Product/Process Change Notice (PCN)

PCN Number: PCN_conDSUB_20250101 Affected Series: WR-DSUB Affected Order Codes: 61800925311 ; 61801525311 61802525311 ; 61803725311 PCN Date: 2024-10-01 (YYYY-MM-DD) Effective Date: 2025-01-01 (YYYY-MM-DD)	Change Category: ☒ Equipment/Location ☐ General Data ☐ Material ☐ Process ☒ Product Design ☒ Shipping/Packaging ☐ Supplier ☐ Software
Contact: Product Management Phone: +49 (0) 7942 - 945 5001 Fax: +49 (0) 7942 - 945 5179 E-Mail: pcn.eican@we-online.com	Datasheet Change: ☒ Yes ☐ No Attachment: ☐ Yes ☒ No

2. Design Change

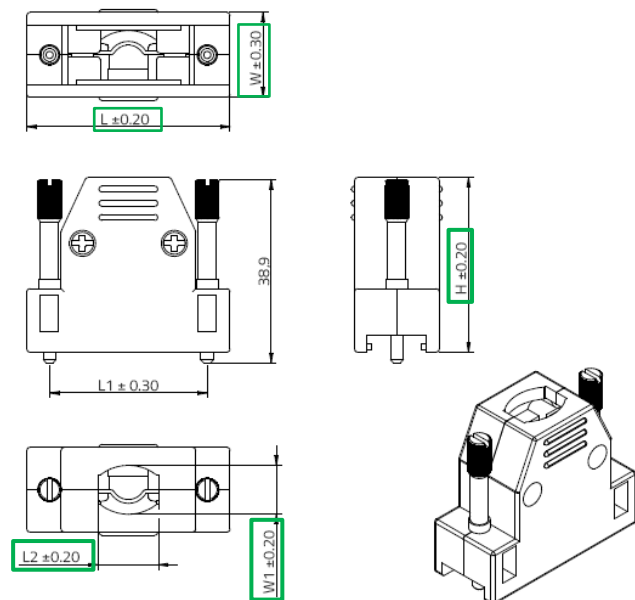
To increase the production capability, Würth Elektronik eiSos will change the production site of the above-mentioned products. This implies changes in design, tolerances, packaging dimensions and quantity. There will be no change in function, or reliability of the product. The new revision of the affected order codes will be sent out after the previous revision is out of stock (according to FIFO - first-in, first-out).

Before change

After change

Part number	B (mm)	C (mm)	D (mm)	F (mm)	G (mm)
61800925311	18.0	31.3	29.8	9.2	11.9
61801525311	18.0	43.2	37.1	10.4	12.8
61802525311	18.2	55.3	41.0	11.2	14.0
61803725311	18.2	70.5	48.0	14.0	15.8

After change

Part number	W (mm)	L (mm)	H (mm)	W1 (mm)	L2 (mm)
61800925311	18.0	31.0	29.8	9.2	11.9
61801525311	18.0	43.2	37.1	10.4	12.8
61802525311	18.0	53.5	40.7	12.0	13.4
61803725311	18.0	70.5	46.7	14.0	16.0
